Countryside Executive Golf Course  
2506 Countryside Boulevard  
Clearwater, Florida  
HSA Project Number 601-5982-00  
October 19, 2006

Subject: **Countryside Executive Golf Course**  
2506 Countryside Blvd.  
Clearwater, Florida  
*HSA Project Number 601-5982-00*

FIGURE 3

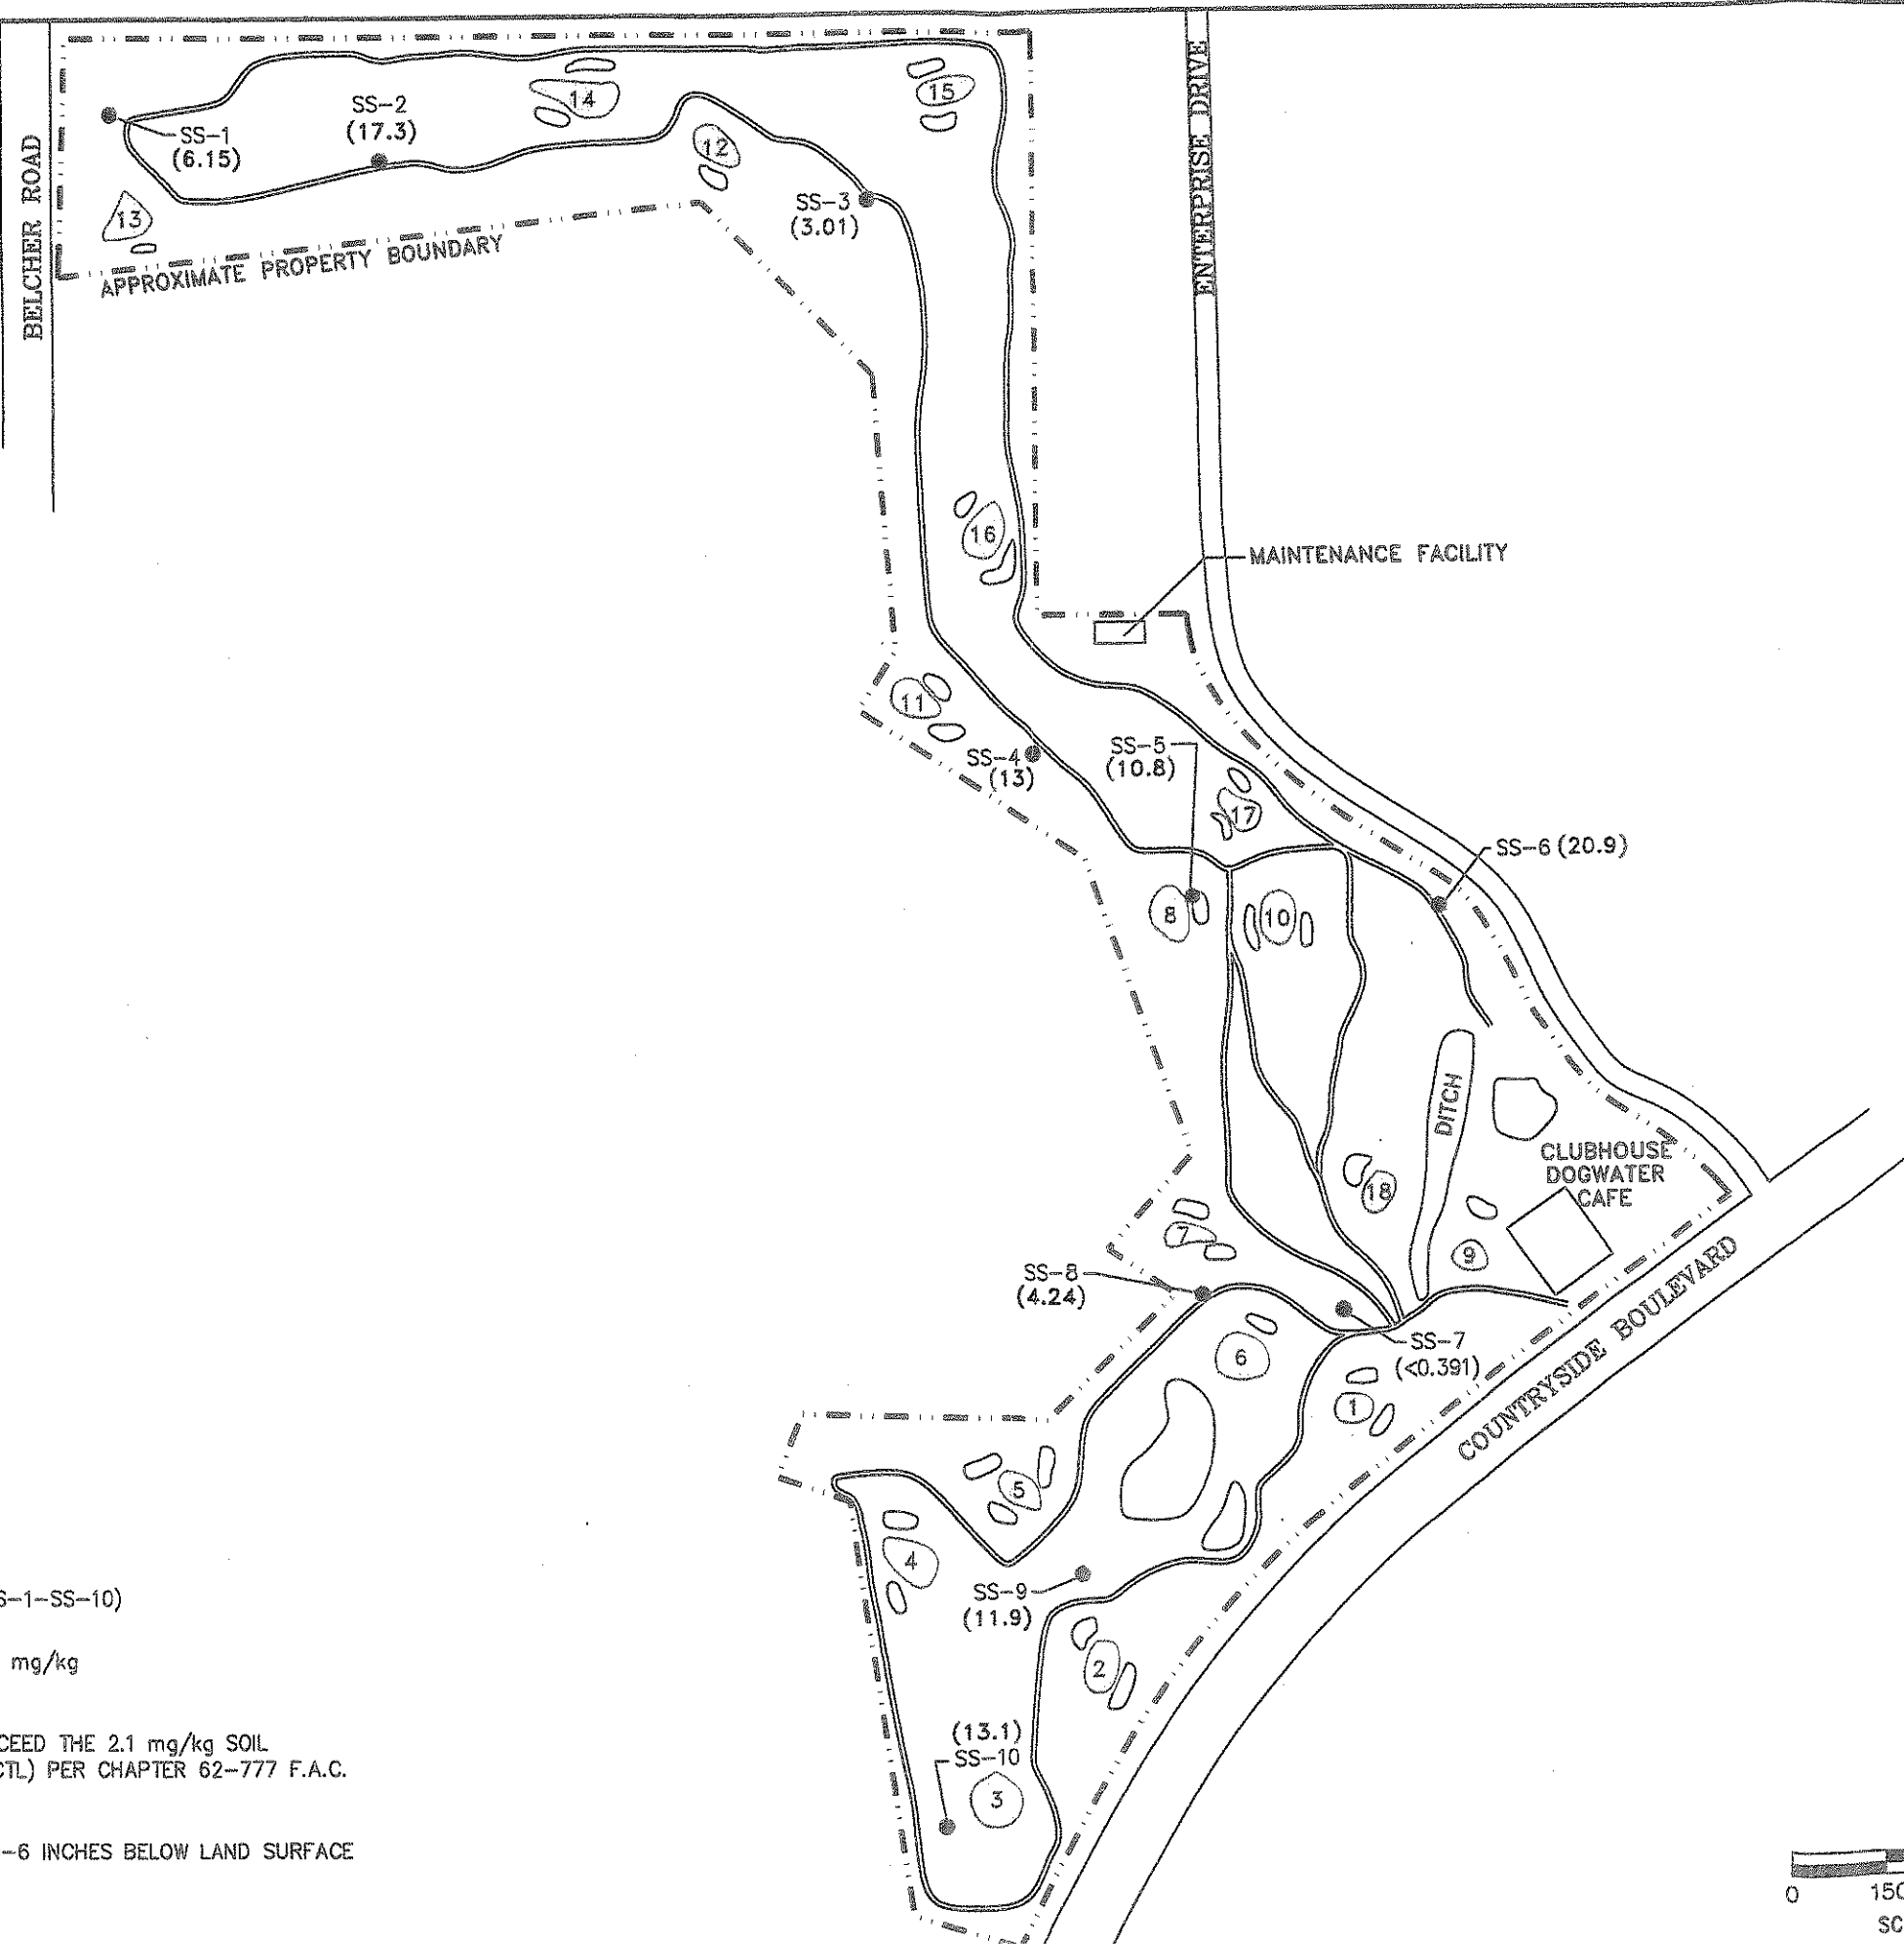
**Comment 1:** *Soil isoconcentration maps of arsenic by depth are needed to indicate where the site has been delineated.*

In lieu of soil isoconcentration maps, site plans depicting arsenic concentrations at varying depths across the site were prepared. In accordance with requirements included under Chapter 62-780, Florida Administrative Code (FAC), soil arsenic impacts were evaluated for depths ranging from land surface to 6-inches bls (**Figure 3**), 6-inches to 2 feet bls (**Figure 4**), 2 to 4 ft bls (**Figure 5**), and 4 to 6 ft bls (**Figure 6**). The depth to groundwater across the site is approximately 4 to 6 ft bls.

JOB NO:	601589200
DATE:	10/3/06
CAD NO:	589200-07
DESIGNED	N/A
DRAWN	SBW
CHECKED	BM
SHEET TITLE	
SOIL EXCAVATION PLAN	
FIGURE 7

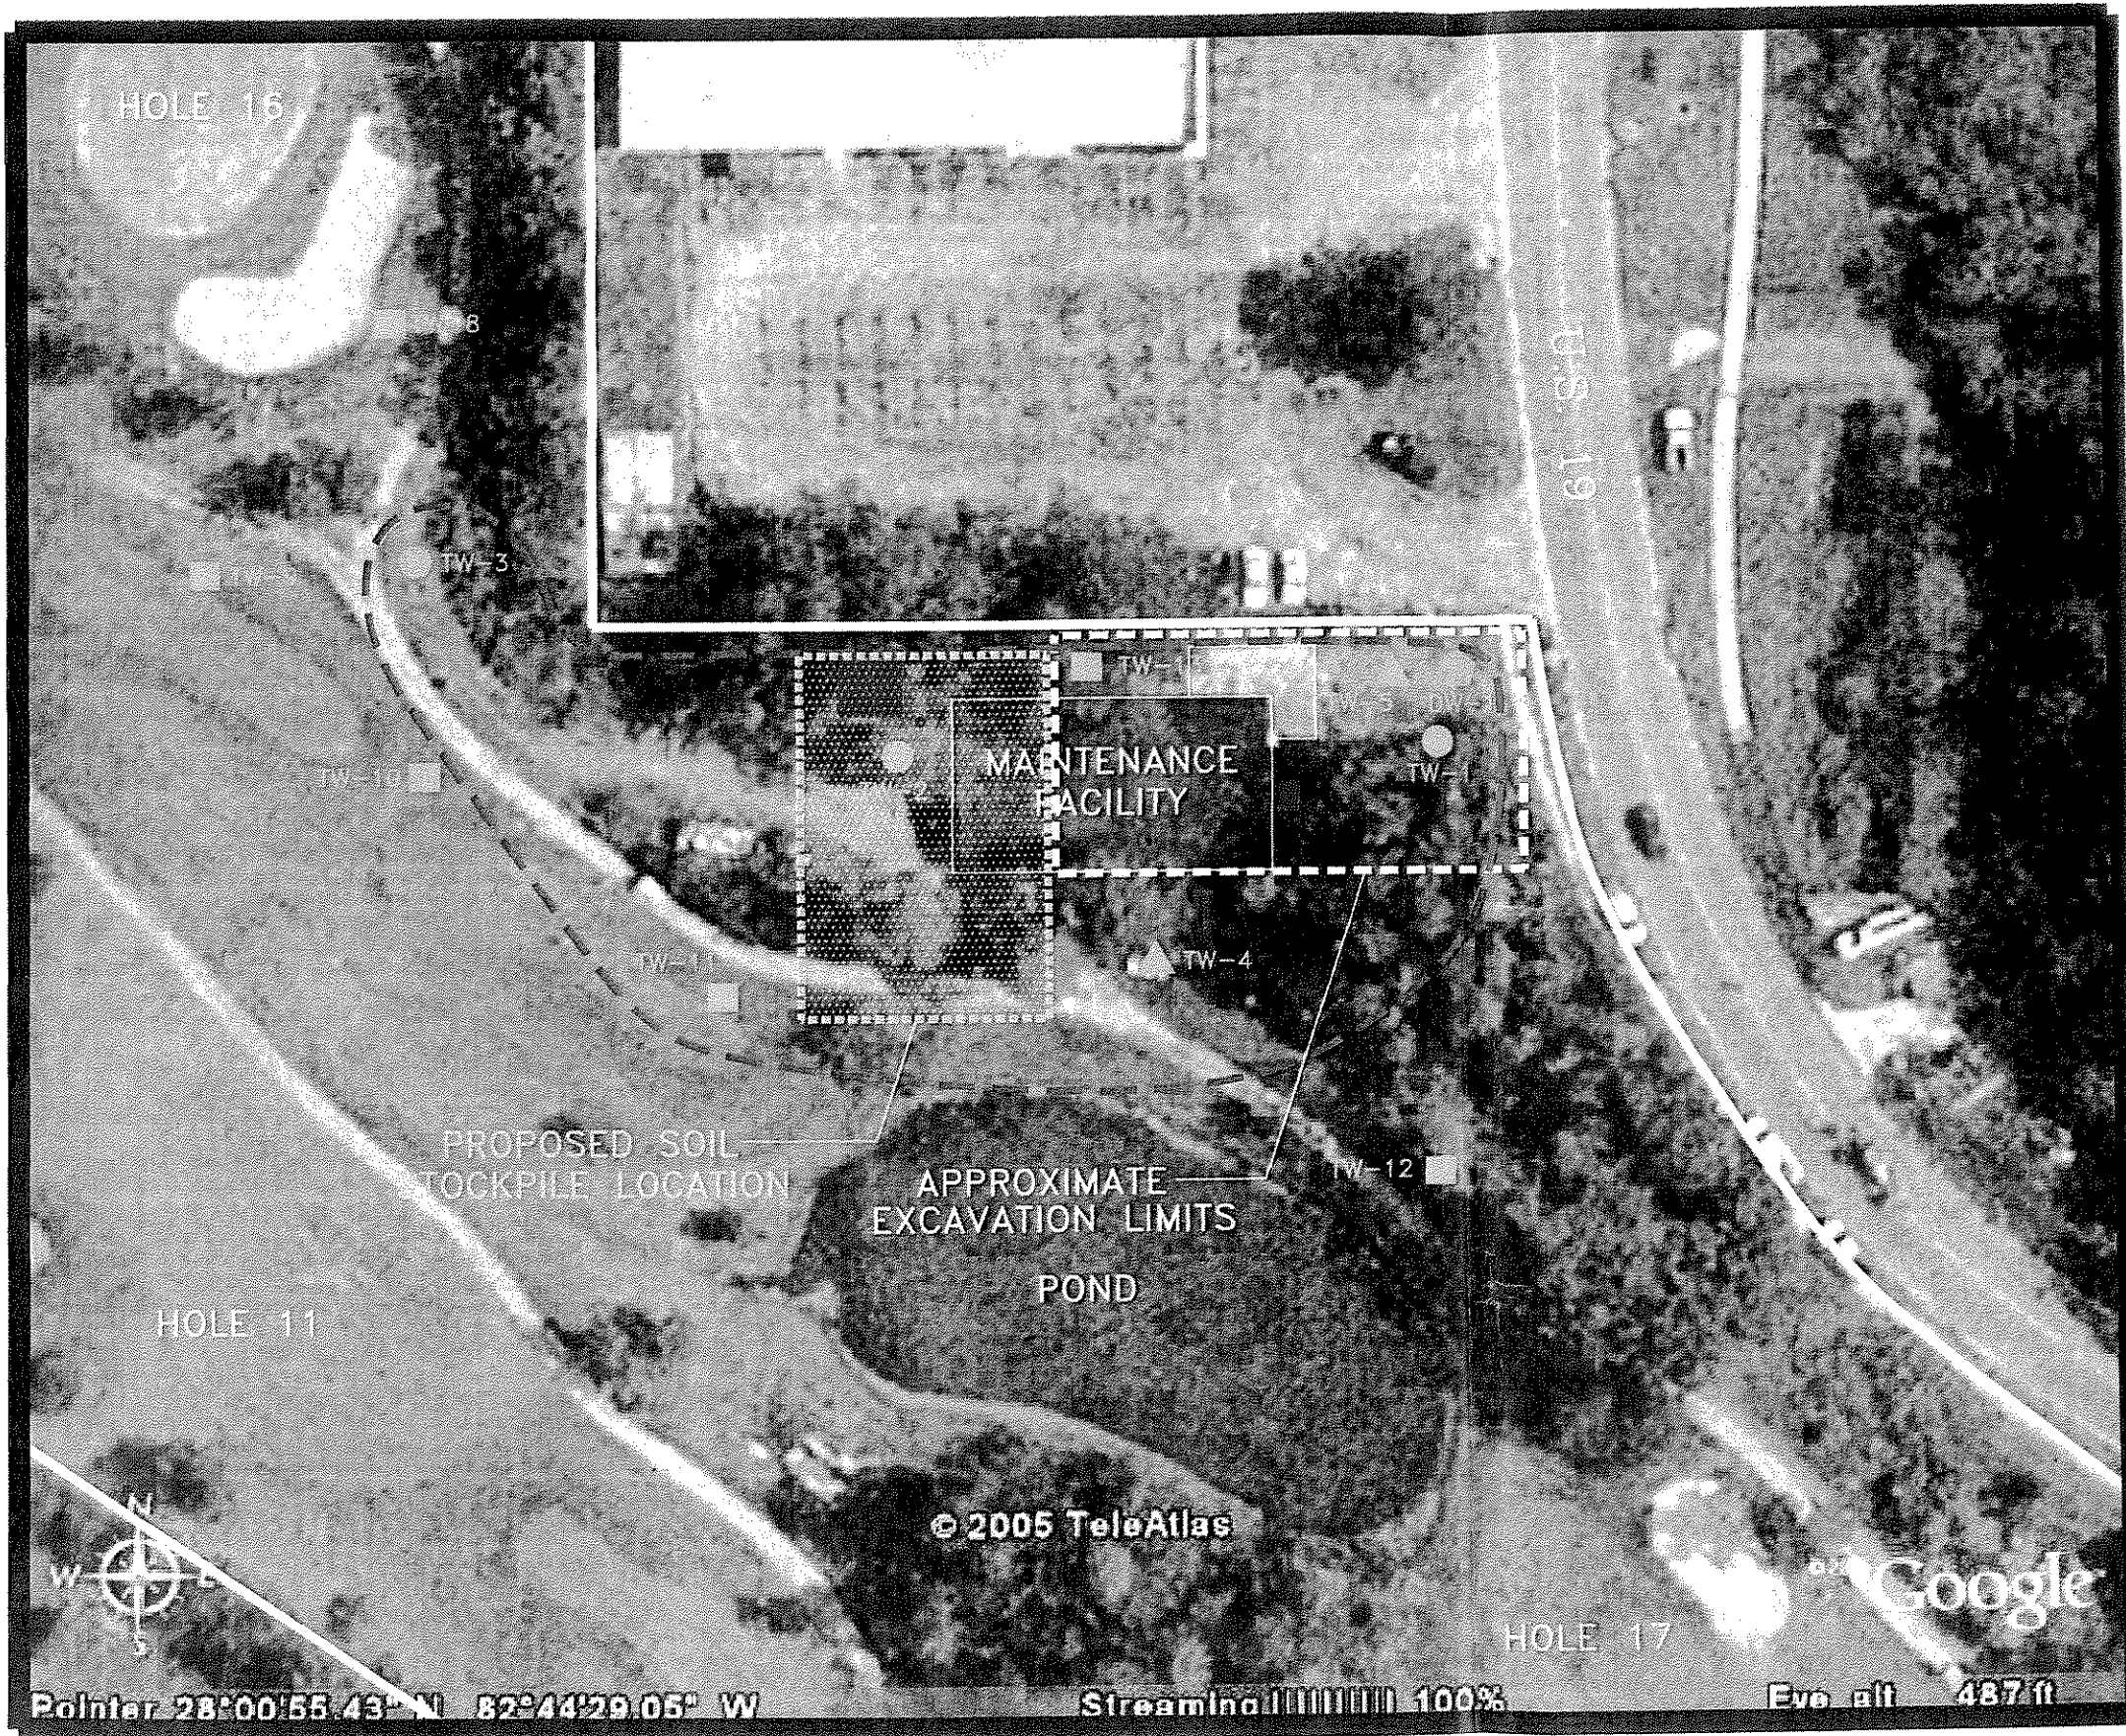
**Comment 4:** *Although the proposed dimensions of the excavation are given, an estimated volume is not given for the excavation. It is also not clear that the proposed stockpile area is large enough to handle the volume (approximately 1,555 cubic yards based on the dimensions given).*

Comment 5: *The proposed stockpile area is reported to be on Figure 4, but does not appear on the Figure.*

**Response:** During excavation, HSA will attempt to direct-load the majority of the excavated soils. Although direct-load is desired, temporarily stockpiling of a portion of the arsenic-impacted soils will likely be required. The location of the proposed stockpile area is included in **Figure 7**.

Response: The location of the proposed stockpile area is included in Figure 7.
